Czech Sport Aircraft a.s.	SERVICE BULLETIN	Czech Sport Aircraft a.s. Na Záhonech 212, 686 04 Kunovice Czech Republic office@czechsportaircraft.com
No. SB-CR-033		Rev.: -
Date: 2016-03-18		
Page: 1 of 10		Date: -

MODEL AFFECTED:	PS-28 Cruiser SportCruiser / PiperSport - under EASA PtF operation only
SUBJECT:	Change from Cylinder Head Temperature to Coolant Temperature measurement method for aircraft equipped with Rotax 912 ULS and 912 S2 series engine with a new cylinder head design.
AIRCRAFT AFFECTED:	PS-28 Cruiser up to S/N C0556 including SportCruiser – all S/N PiperSport – all S/N
COMPLIANCE:	As per EASA AD 2015-0240 (for Rotax engines)

Figure 2 - Part number location of cylinder head

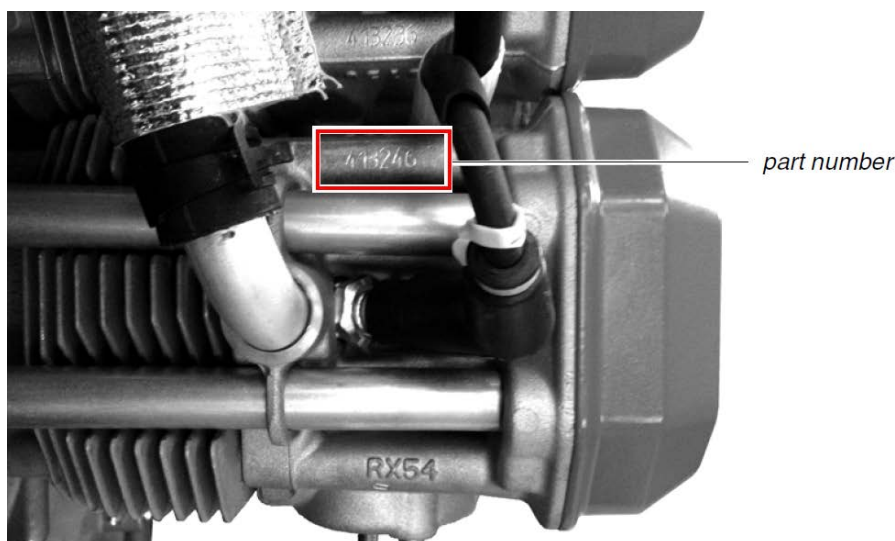
- b) **The temperature sensors** are located on cylinder 2 and 3. To recognize whether the engine is equipped with the new cylinder head design (P/N 413185 for 2/3 cylinder head) or not, read the Part number of the 2/3 cylinder heads, see Figure 2.

3. Check the part numbers of the cylinder heads at the measuring positions 2/3, see Figure 1 and Figure 2 above.
Send a written report to Czech Sport Aircraft a.s. about the check result (Date, Aircraft S/N, New cylinder heads design was found/not found.)

Figure 3 - Difference between old and new cylinder head design and temperature sensor position

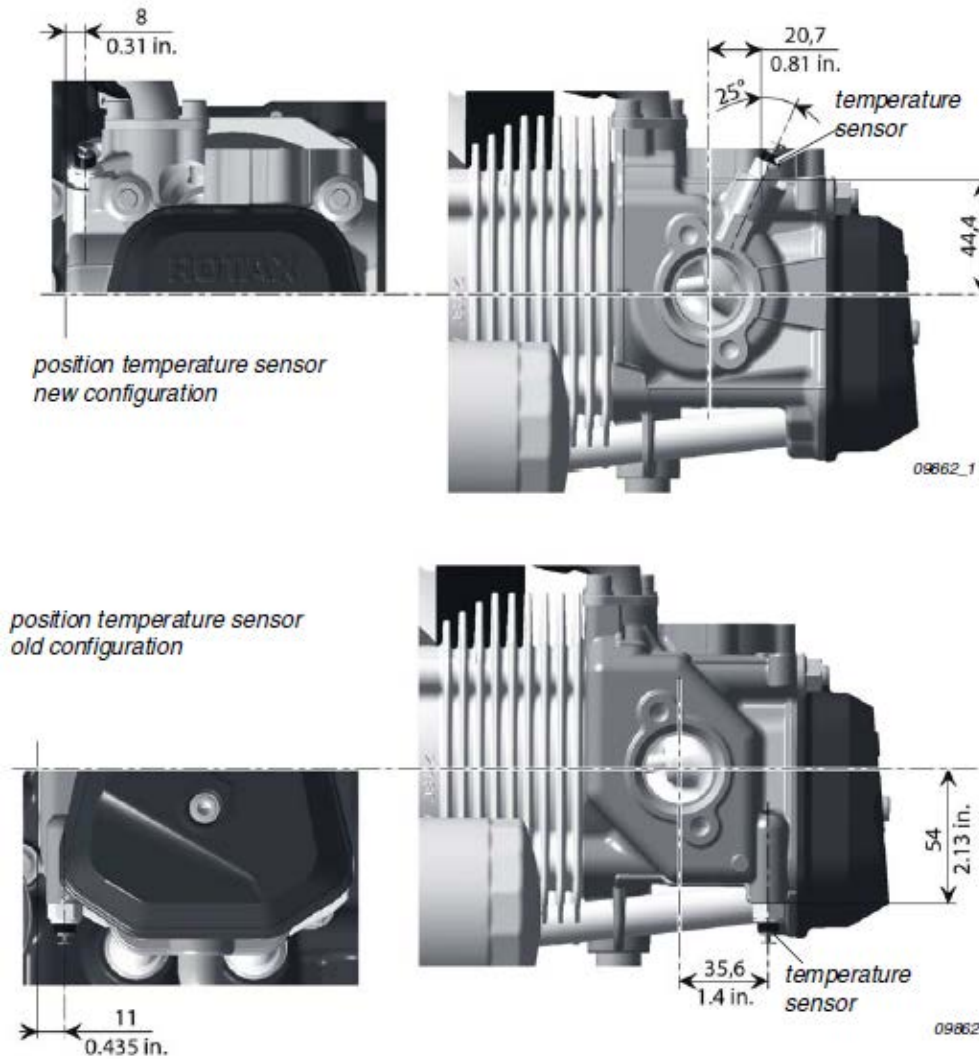
With the change to a new cylinder heads design (P/N 413185 at cylinder head position 2/3) no longer the Cylinder Head Temperature is measured, but the Coolant Temperature.

The measuring position of the temperature sensor has changed. With this new installation position of the temperature sensor, a loss of coolant can be recognized easily. The change to the new cylinder heads does not affect the cooling capacity.

- c) To recognize the **difference between the old and new cylinder head design and the temperature sensor position**, see Figure 3.

Figure 5 - Extension of the air cooler inlet hole in the engine bottom cowling

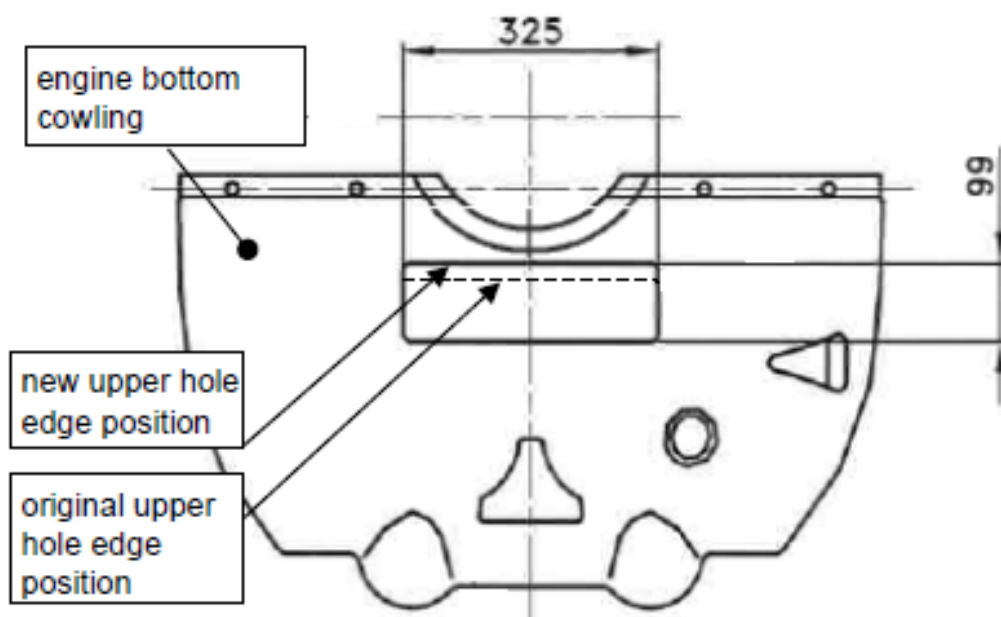
Due to these changes the Coolant Temperature (CT) instead of the Cylinder Head Temperature (CHT) in the aluminium is displayed. For that reason it is necessary to check/correct the Coolant Temperature limit (120°C) displayed on the instrument panel, check/correct its naming (CT instead of CHT). To improve the engine cooling characteristics, an extension of the air cooler inlet hole in the engine bottom cowling must be applied.

10. Extension of the air cooler inlet hole in the original engine bottom cowling.

- 10.1. Use the engine bottom cowling, measure out and mark new hole top edge acc. to the Figure 5 below. The new top edge is moved upwards.
- 10.2. Cut off the top rim accordingly to the marking and clean the hole.
- 10.3. Fit in place and adjust the cut off top rim and laminate it back in the extended cowling inlet hole.
- 10.4. Use an additional fiberglass and apply for laminating of side parts of the cowling hole.
- 10.5. Carry out sanding for good adhesion of the repair coats.
- 10.6. Apply a sufficient primer and top coat to restore the original colour design of the surface.
